Proposed Amendment to Unit 1 Proof and Review
Technical Specification Tables 3.3-1 and 3.3-3 Concerning
Action Statements 6.b and 19.b, Respectively

Catawba Nuclear Station
Unit 1

Proposed Amendment to Proof and Review Technical Specifications to
Allow Changing between Operational Modes 5 and 6
with the Control Area Ventilation System Inoperable

UNIT ORGANIZATION
 CATAWBA NUCLEAR STATION
 Figure 6.2-2

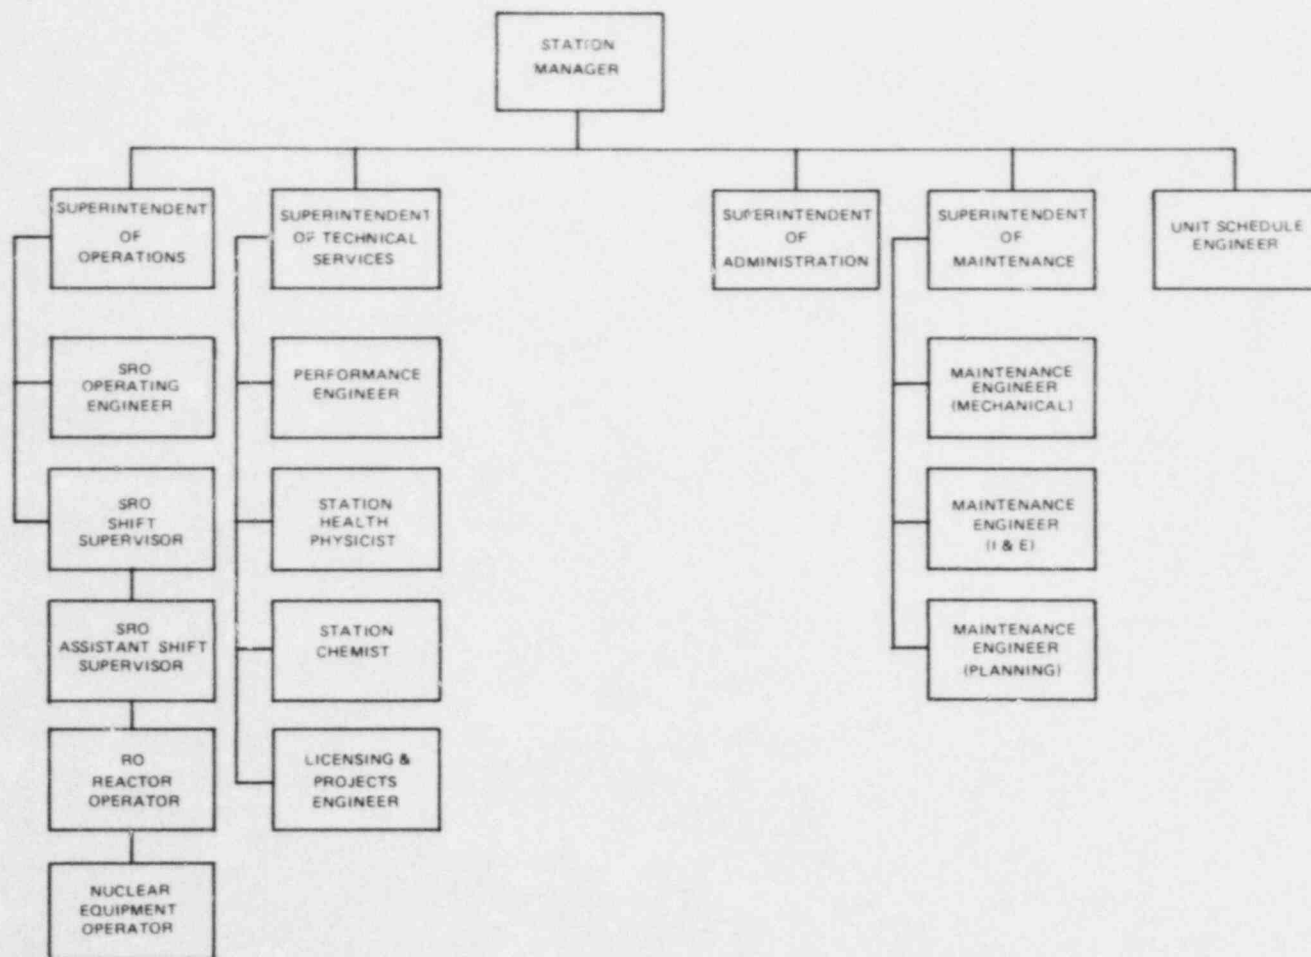
Also, a new Figure 6.2-2 "UNIT ORGANIZATION" is provided which shows the organization that will be in place at Catawba at the time of fuel load.
